NOVEMBER 2019

PL6

NON MATERIAL
AMENDMENT
PLANNING
APPLICATION
& CONDITION 4
DISCHARGE

44 A GLOUCESTER
AVENUE LONDON
NW1 8JD

2.6 CHANGES TO CONSENTED BASEMENT AND GROUND FLOORS

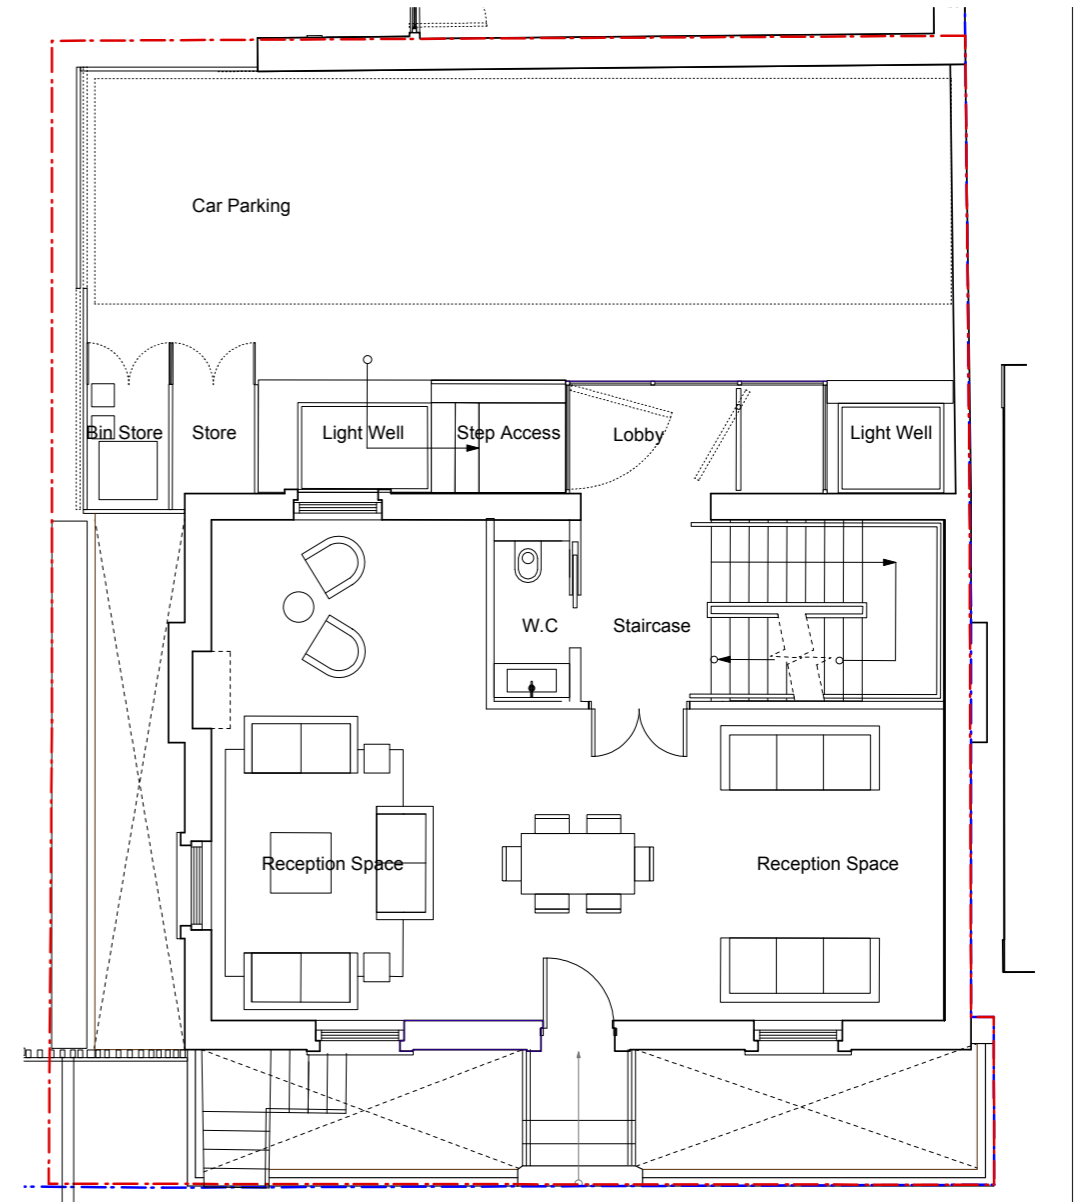
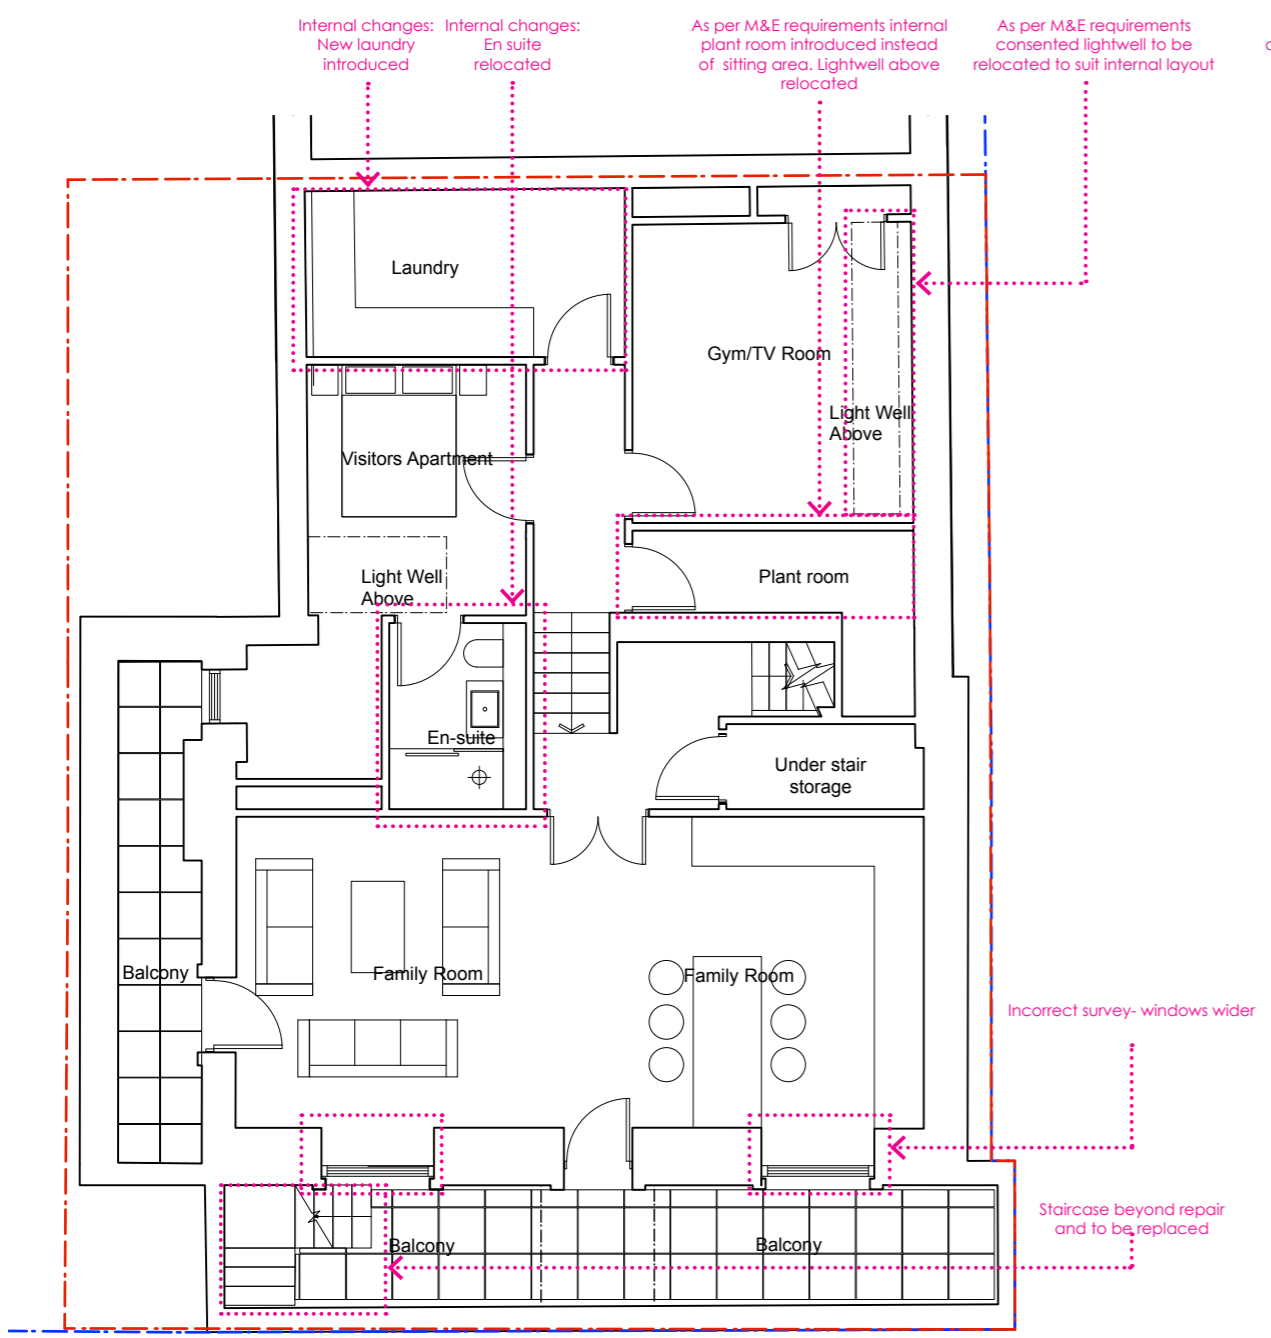
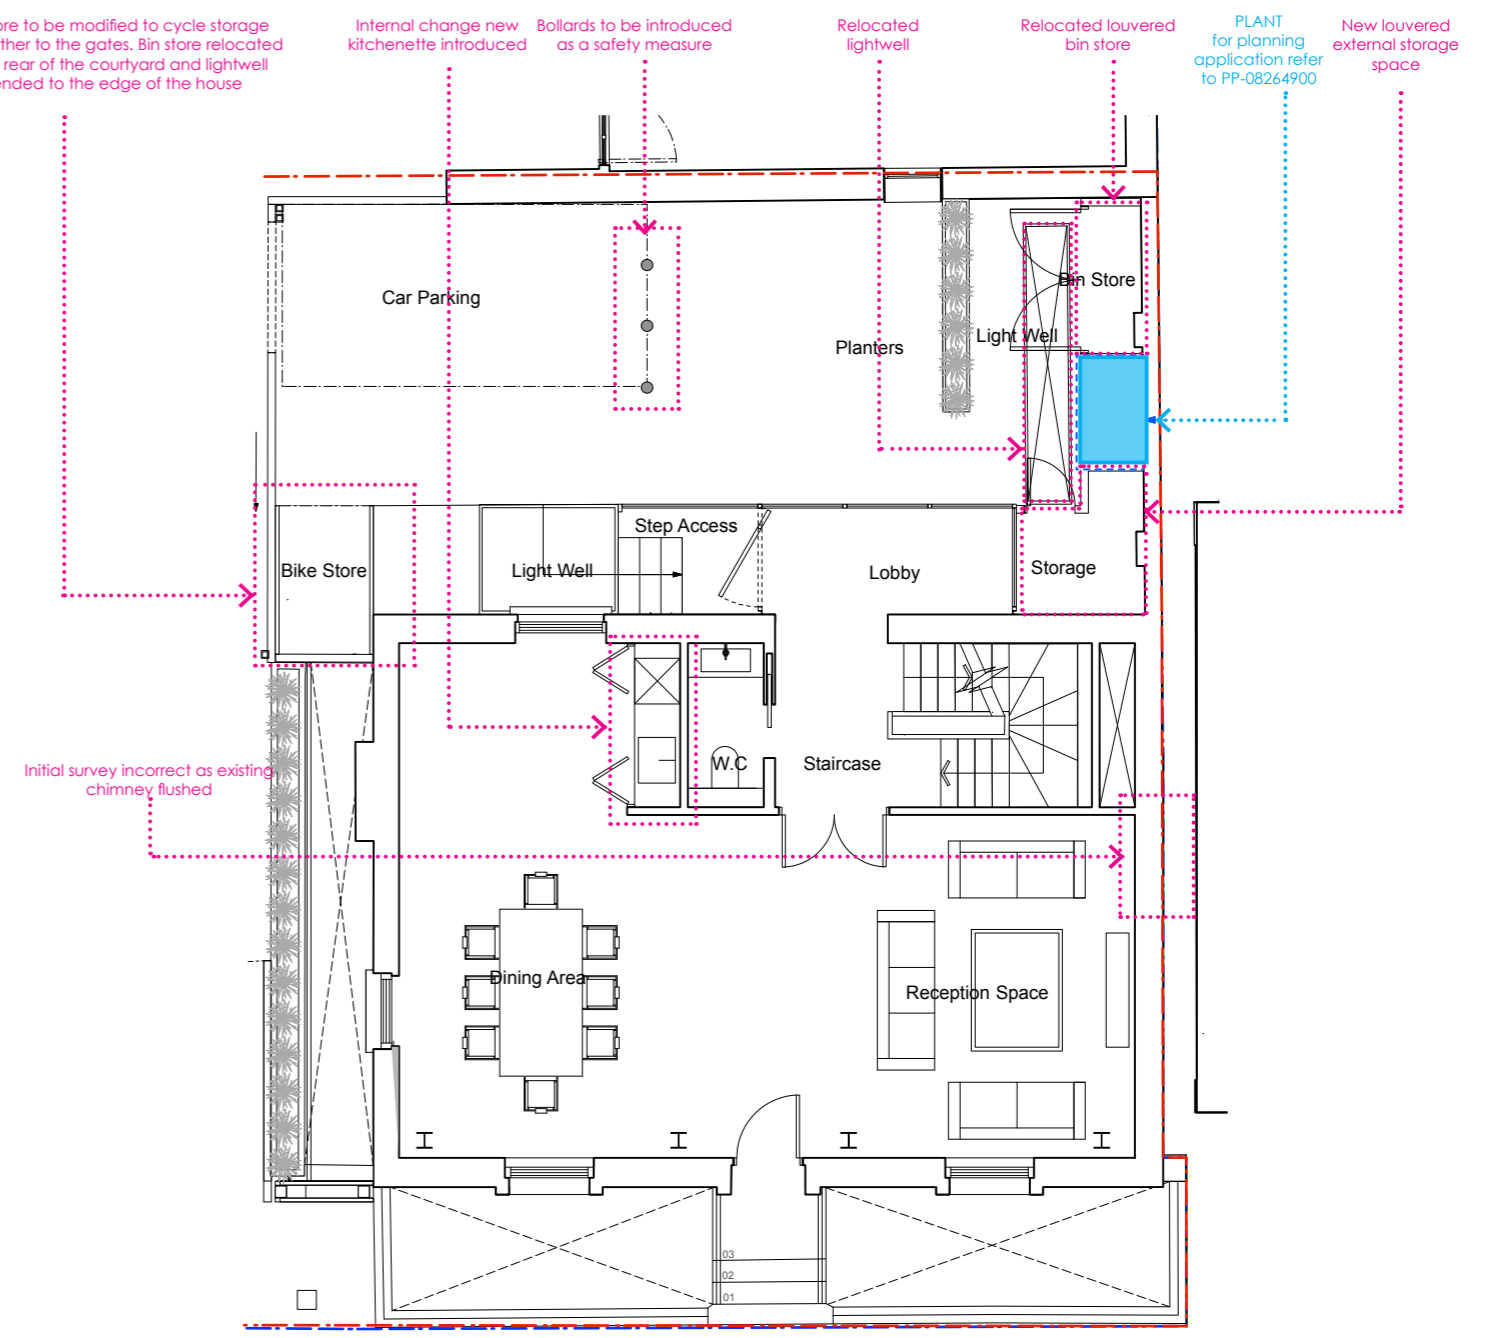
- Side basement balcony to have double door access instead of single door.
 - Approved store modified to cycle store, bin store relocated to rear of the courtyard and the base of the lightwell extended to the edge of the house

- Planters have been placed in the rear courtyard
 - Lightwell relocation and change in plan to adapt to new layout
 - Bollards have been added to the parking space to the rear courtyard. Specification for the pavers incorporated in the scheme

2.7 CHANGES TO CONSENTED FIRST AND SECOND FLOORS

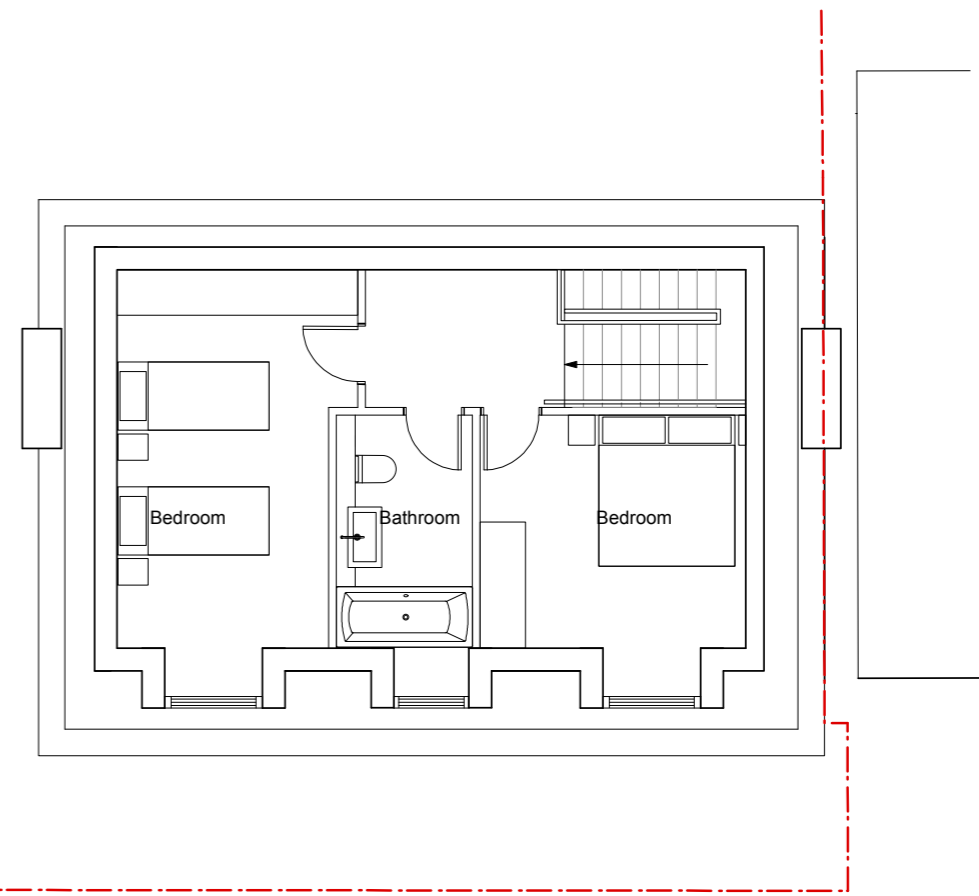
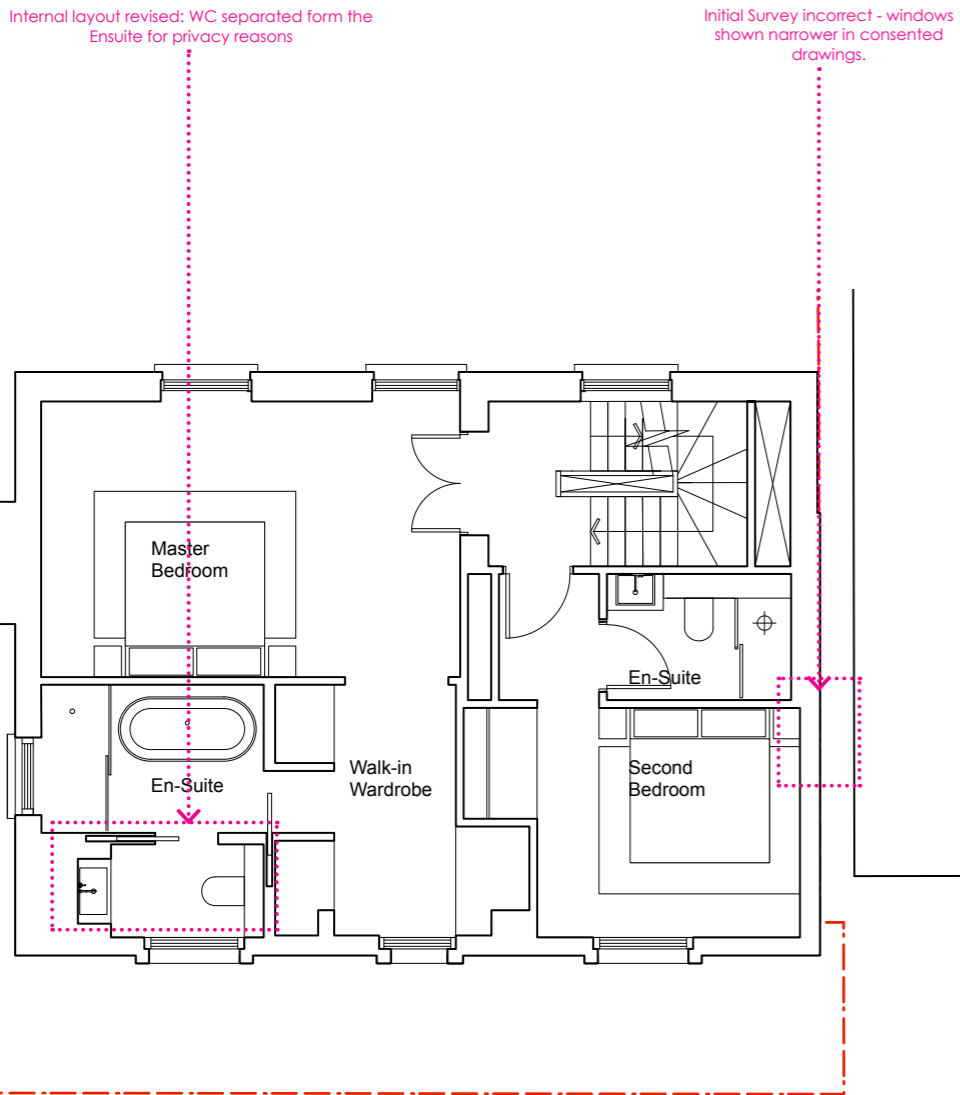
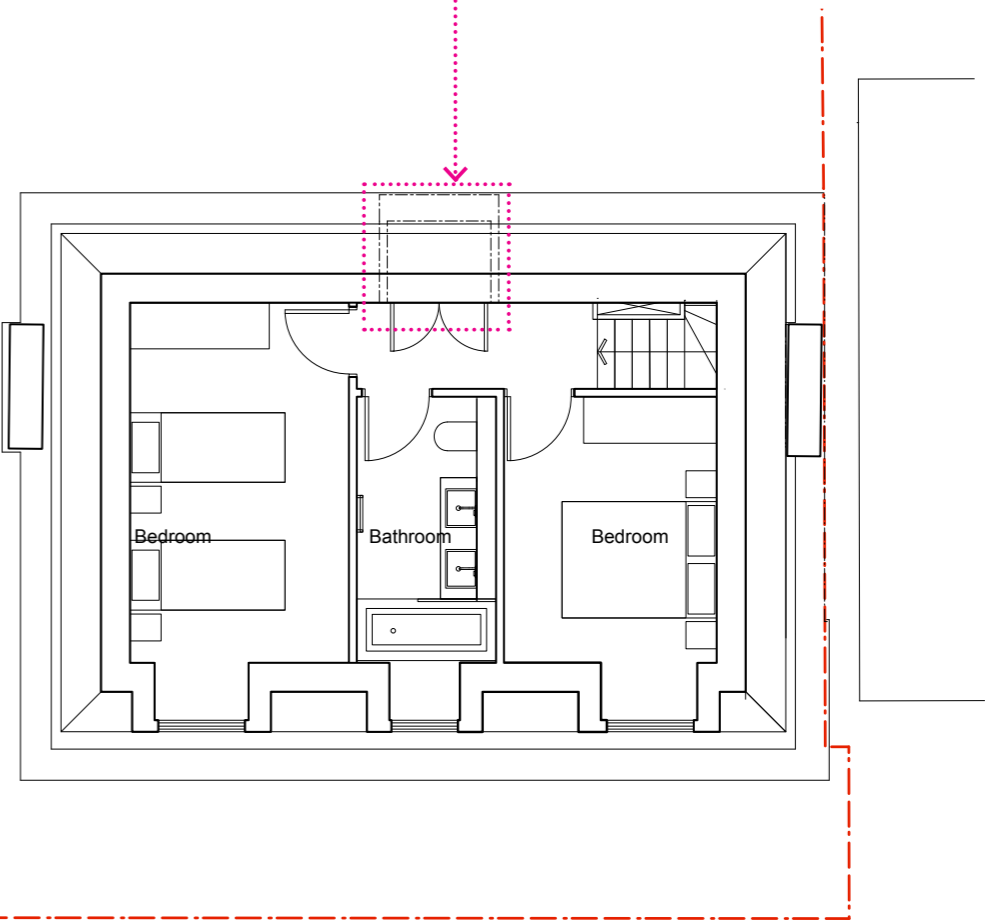
Internal under roof storage added
